Staff Report

Re: Alameda Creek Watershed Center Public Art Project – Landscape

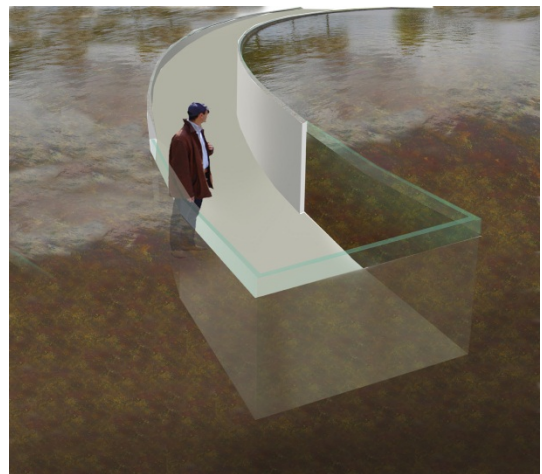
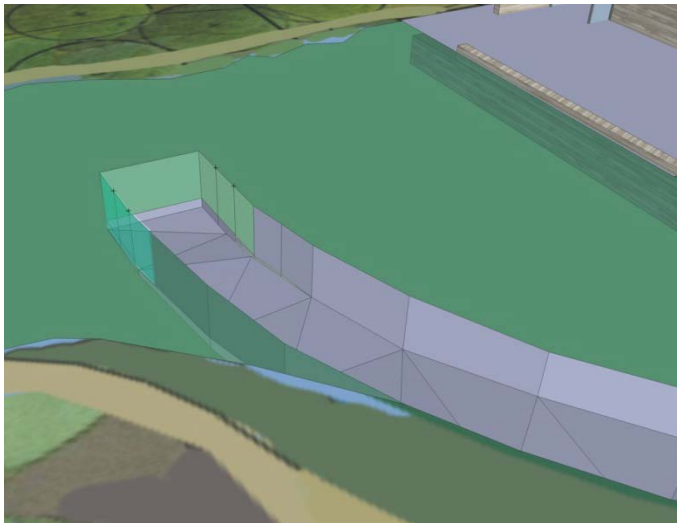
Brest van Kempen's revised design includes decreasing the size of the ramp and changing the materials of the ramp. The width of the ramp would decrease by 2 feet, from 8 feet to 6 feet, and the length of the ramp would decrease by approximately 30 feet, from 100 feet to 70 feet, by increasing the slope of the ramp to no greater than 1:12. The greater slope would necessitate a handrail along the length of the ramp. The artist also proposed making the walls of the ramp concrete, with the exception of the last 6 feet of the ramp that would remain glass. In addition, he would shorten the height of the glass by 1 foot, from 5 feet to 4 feet, adding a 1 foot concrete curb so that the top of the glass remains at 5 feet above ground level.

While the concept of the landscape piece is strong, staff believes the design has been compromised with the replacement of the majority of the glass walls with concrete. In addition, since the artwork is still early in design phase, staff is not confident that the project can be executed within the \$500,000 budget. Staff's experience is that costs will increase as design proceeds; in addition, as the work will be completed by the General Contractor through a bid process, staff's experience has been that the bids generally come in greater than the cost estimates. Given the changes to the design and budget constraints, staff recommends proceeding with the entryway project by Mark Brest van Kempen, which we are confident can be executed in budget. For the remaining funds, estimated to be approximately \$250,000, staff recommends identifying alternate locations for an artwork in the landscape and conducting a new selection process for that opportunity. Staff will present an updated project outline for approval at a future VAC.

Motion: Motion to reject revised conceptual design and budget for the landscape artwork by Mark Brest van Kempen for the Alameda Creek Watershed Center.
